GMS Composite Knitting Ind. Ltd. (New Building)

Sardaganj, Kashimpur, Gazipur-1346, Bangladesh,
(23.96859, 90.29699)

24th & 31st May & 06th September 2021

Observations

2.4.4 FOUNDATION COMPLIANCE STUDY

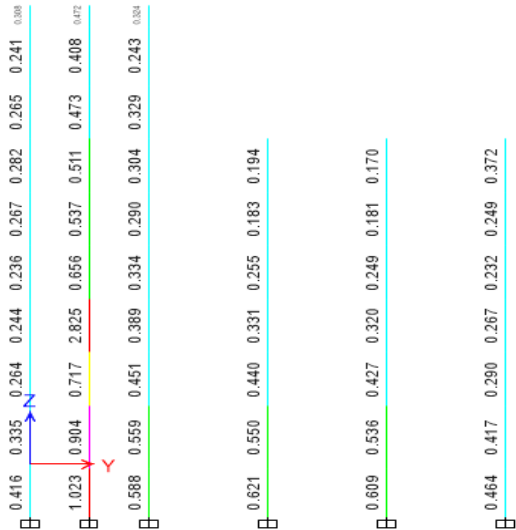
Factor of Safety Considered 2 instead of 2.5

Column shows overstressed as per PMM ratio > 1.
 But no recommendation provided in the design report.

Footing Layout Plan

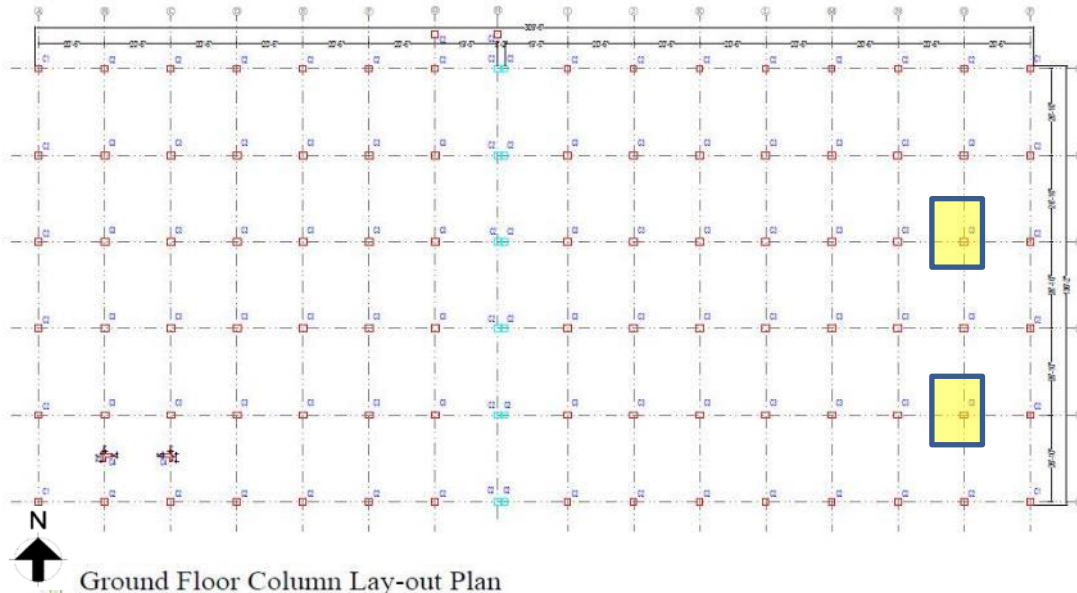
Retaining wall layout plan not shown in drawing

Building engineer is required to survey the structure & prepare as-built drawings.

Ground Floor Column Lay-out Plan

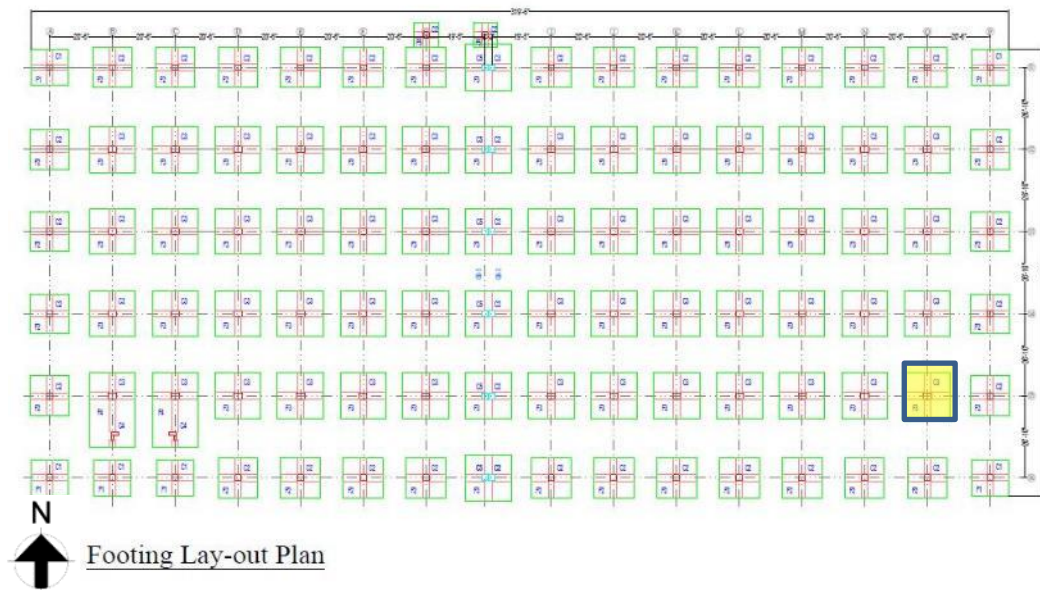
Cursory calculation indicates that columns are stresses above normal design limits at the marked locations considering 3 kPa live load on typical floor. Building engineer to review design, loads and columns stresses.

Load plan for 4th floor

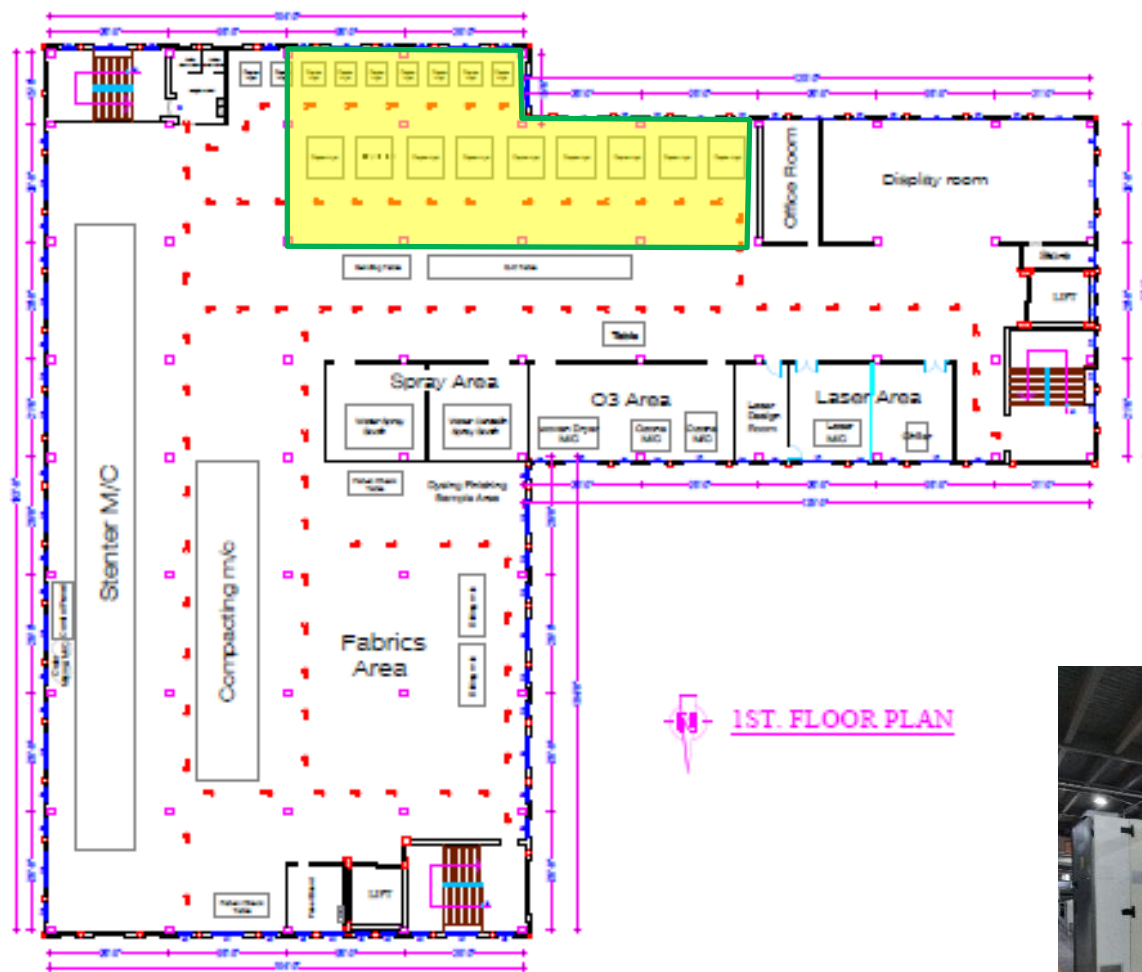
Live load at storage areas are considered as 3 KPa in prepared load plan. However, as per BNBC-Part 6 live load for light storage areas is required to be considered as 6 KPa. Building engineer is required to revise the load plan as per BNBC part-6.

First floor layout plan

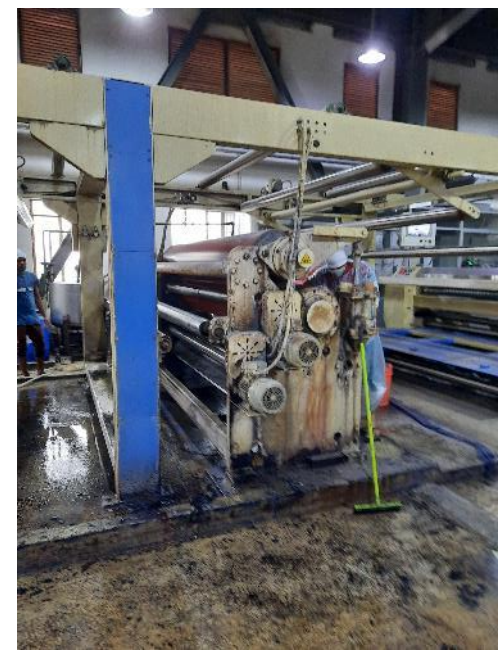
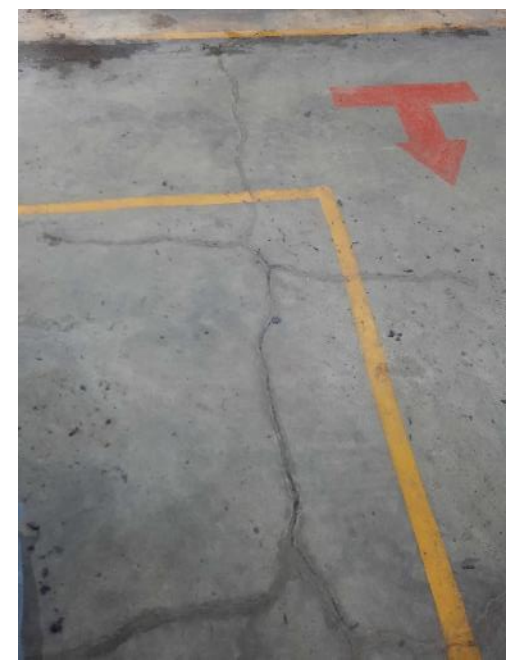
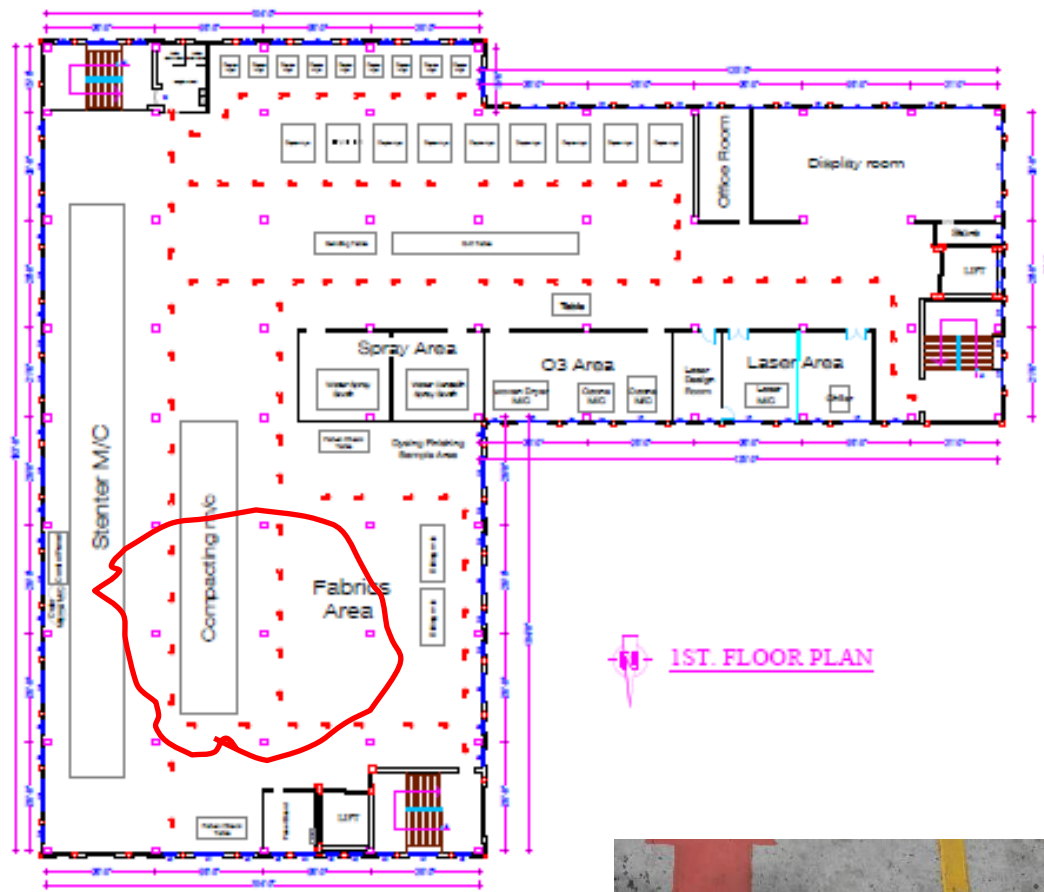
Significant vibration was felt on the first floor due to operation of heavy machineries. Building engineer is required to investigate the long-term effect of the vibration and suggest remediation.

Crack observed on the 1st floor slab apparently due to presence of heavy machineries and vibration. Building engineer is required to check the extent of the crack and suggest remediation.

FOOTING SCHEDULE

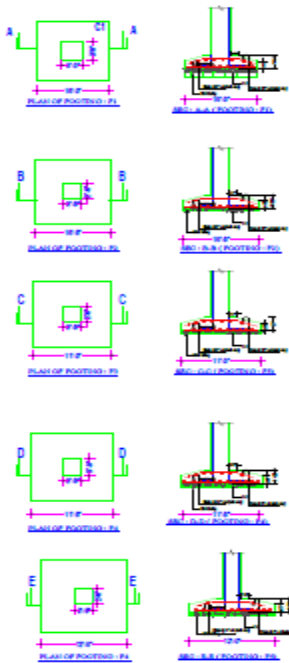
Depth of footing not mentioned in the drawing.

Some footings required area > provided area. Building engineer is required review the design, load & footing stresses.

Vertical bracing missing at ground floor

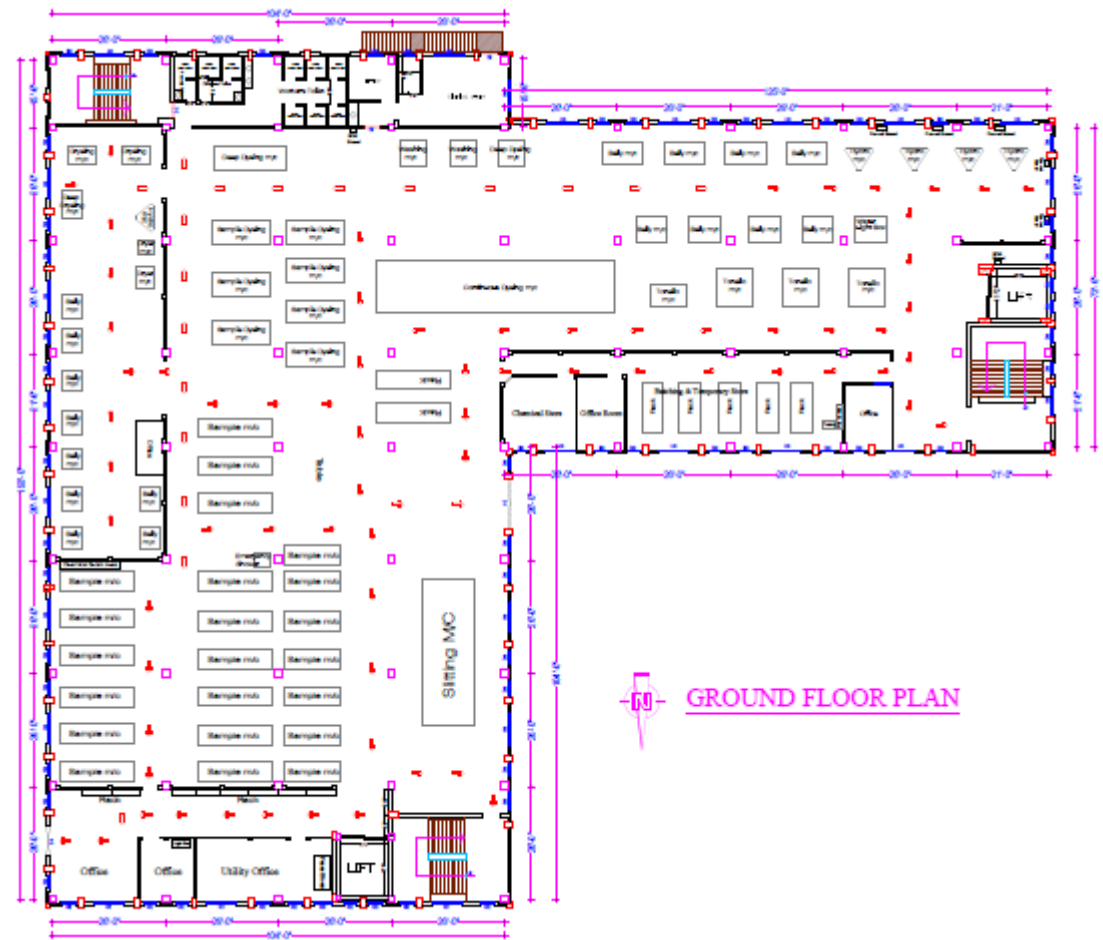
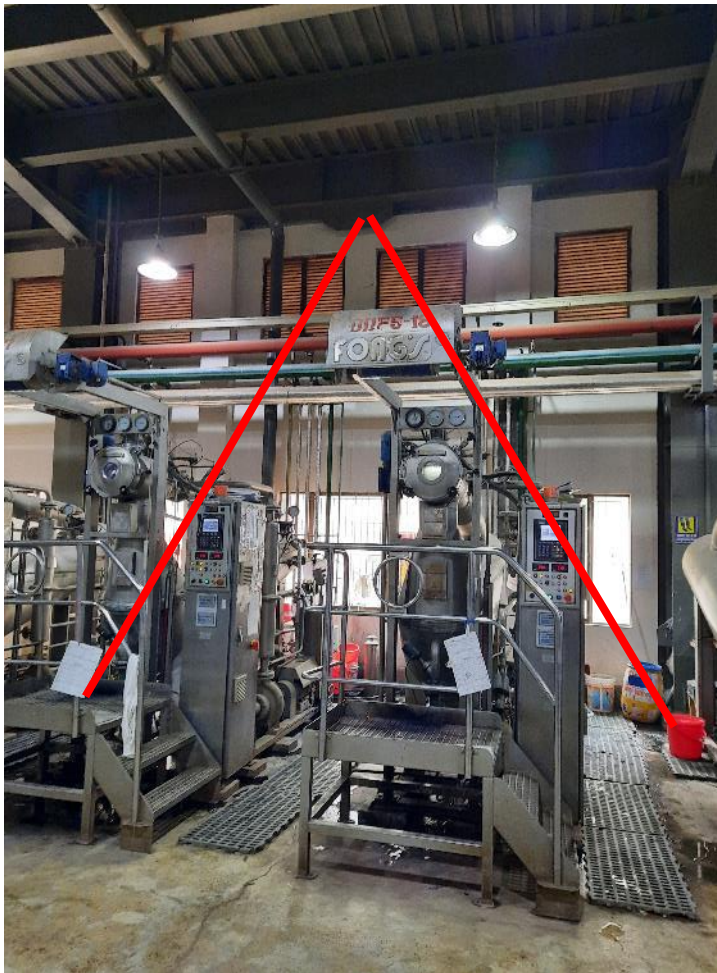
Vertical bracing at ground floor found missing in the marked location. Building engineer is required to install the missing bracing also check the lateral stability in long direction.

Crack observed on roof slab. However, the factory has repaired the crack by bituminous treatment. No investigation report was available to determine the reason of crack, extent of crack & detail repair methodology. Building engineer is required to investigate the reason of crack, extent of crack and check whether the crack are repaired with suitable method.

NTPA load combination considered in software-based analysis model

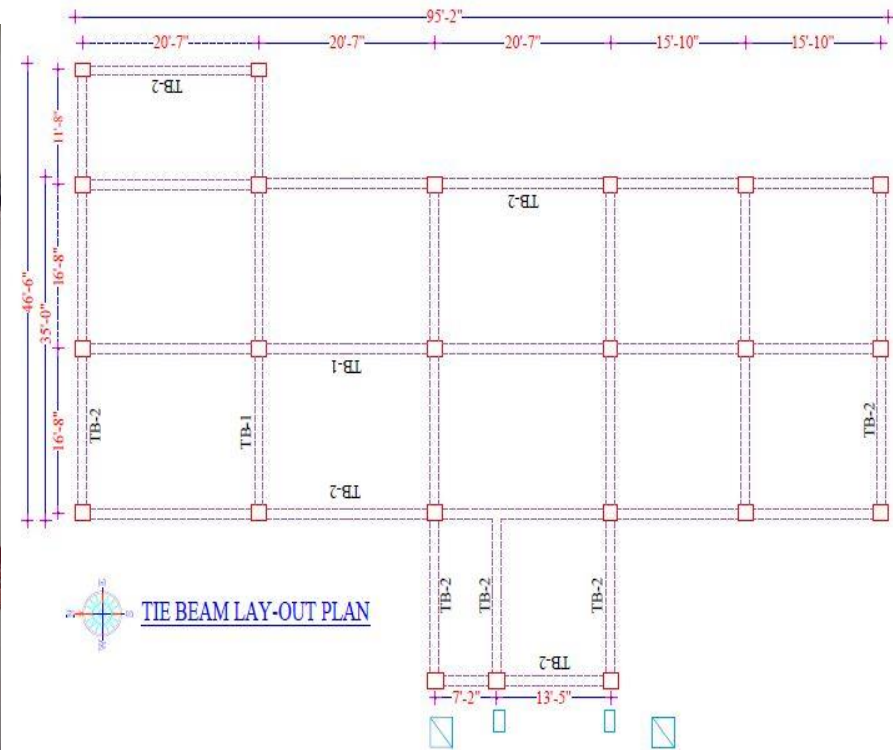
The building was constructed between November 2016 and December 2017 but in software-based analysis load combination has been considered as NTPA which doesn't comply with BNBC part-6. Building engineer is required to revised the prepared DEA report as per BNBC part-6.

Tie beam layout

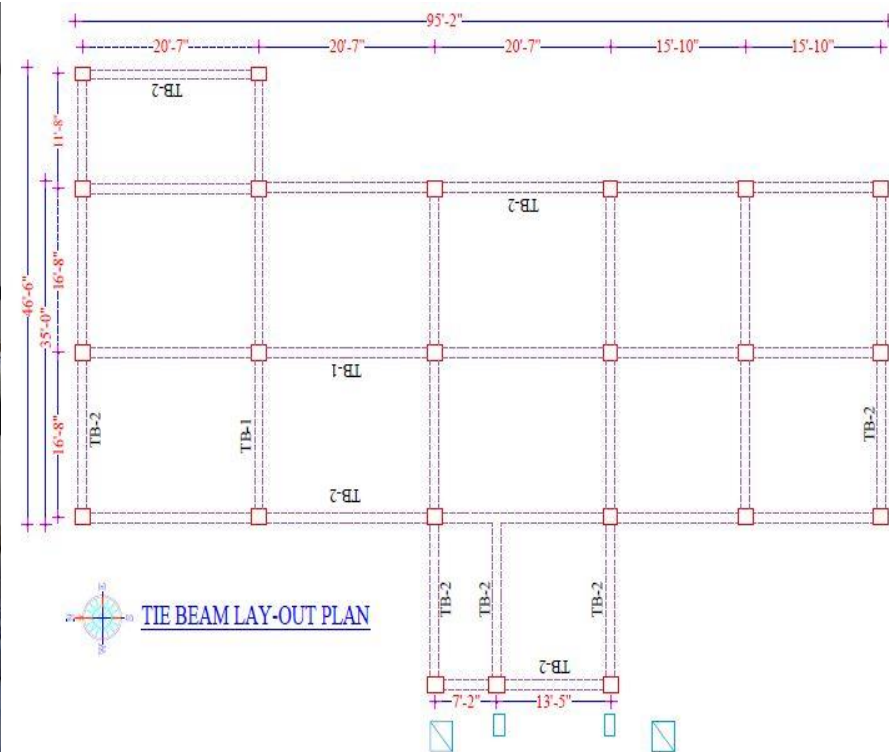
Tie beam of 1st floor were found at different levels but not shown in drawing. Also, dimension of tie beam at different levels differs from each other which is not shown in drawing. Building engineer is required to update the as-built drawing.

Tie beam layout

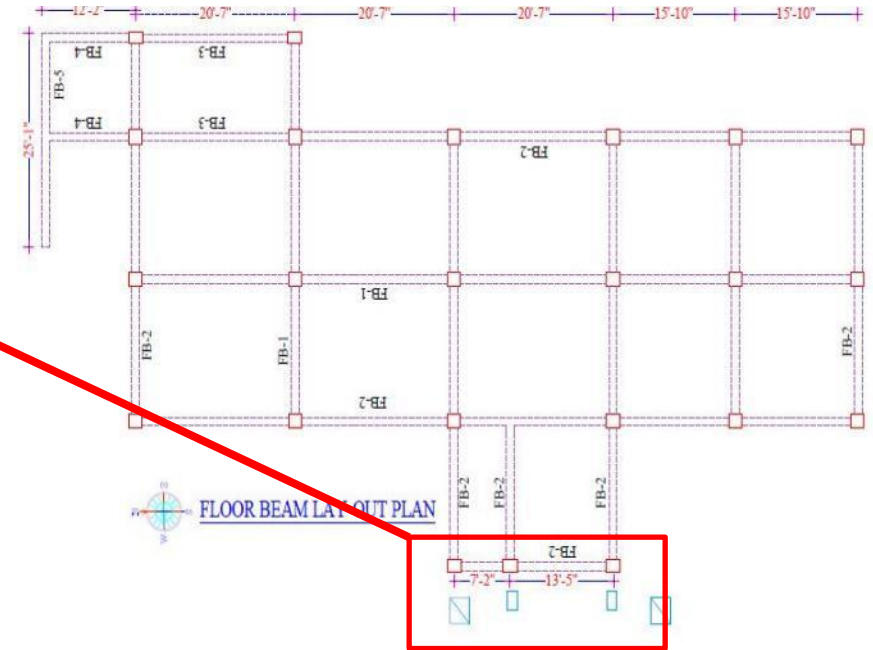
Tie beam of Ground floor were found at different levels but not shown in drawing. Also, dimension of tie beam at different levels differs from each other which is not shown in drawing. Building engineer is required to update the as-built drawing.

Cantilever beam at south side

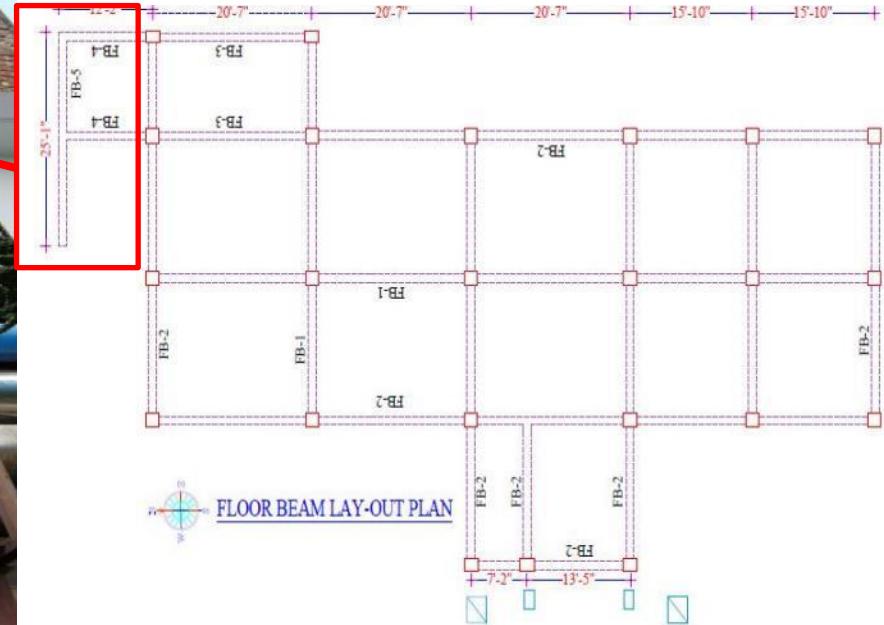
Cantilever beams at south side extended area are not shown in drawing.
Building engineer is required to update the as-built drawing.

Core cutting hole filled with mortar

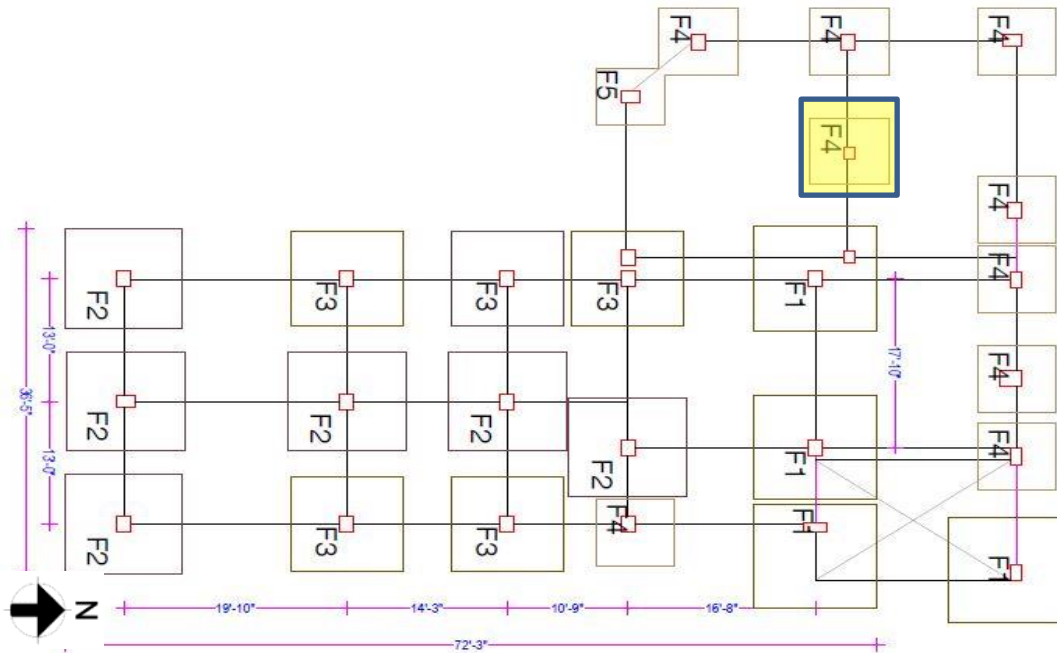
Core cutting hole were found filled with only mortar which may impact on column stress level.
Building engineer is required to fill all the core cutting hole with micro-concrete.

FOS in soil test report considered as 2.50

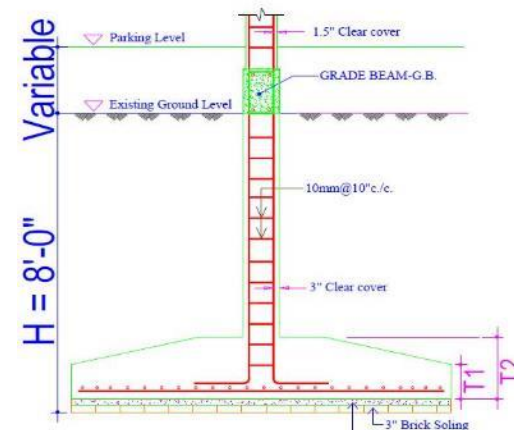
In geotechnical investigation report, factor of safety of soil capacity considered as 2.50 and foundation depth mentioned at 2.44 m depth in provided drawing. However, in prepared DEA report soil bearing capacity used for 3.04m depth and factory of safety used as 3.0 which may result in significant change in foundation capacity calculation. Building engineer is required to revised the foundation capacity calculation.

One location of concrete core on column

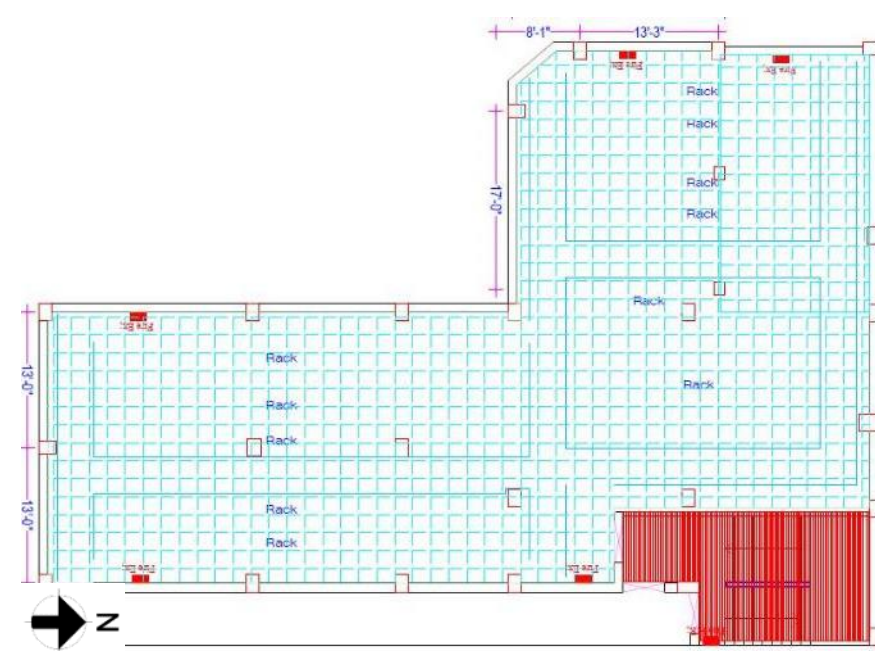
At the time of inspection one set of concrete cylinder core test report from column was available for this structure. However, only one location of the cores was found at site. Building engineer is required to produce a core layout and mark all the locations of the taken cores.
